Service Bulletin

Service bulletin # HK2004-03 October 2004

Model: DVD22

Subject: Locked in POWER ON

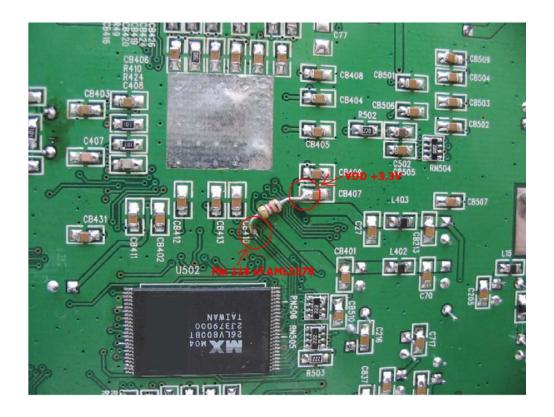
In the event you receive a DVD22 with the complaint: "The unit will turn ON with "POWER ON" in the display, but the unit is locked up and will not read a disc, nor will pressing any button accomplish anything, even the Power button", follow the instructions below.

Synopsis: Add a 4.7K ohm resistor to the indicated area on the bottom of the Main PCB.

- 1) Remove the eight plated screws holding the top cover to the unit; remove the top cover.
- 2) Remove the four molex connectors and one small FFC cable from the Main PCB.
- 3) Remove the five plated machine screws (top) and the five black screws (rear panel) from the Main PCB.
- 4) Remove the Main PCB from the unit.
- 5) On the reverse side (bottom), solder a $4.7K\Omega$ 1/8W resistor (h/k part#299-4.7K or WLD5.630.472) to the indicated area. (Attach one end of the $4.7K\Omega$ resistor to one end of CB407, the other side, to a small through-hole pad near the silkscreen label "CB410").
- 6) Replace the Main PCB and assemble the unit in reverse order.
- 7) Test the unit.
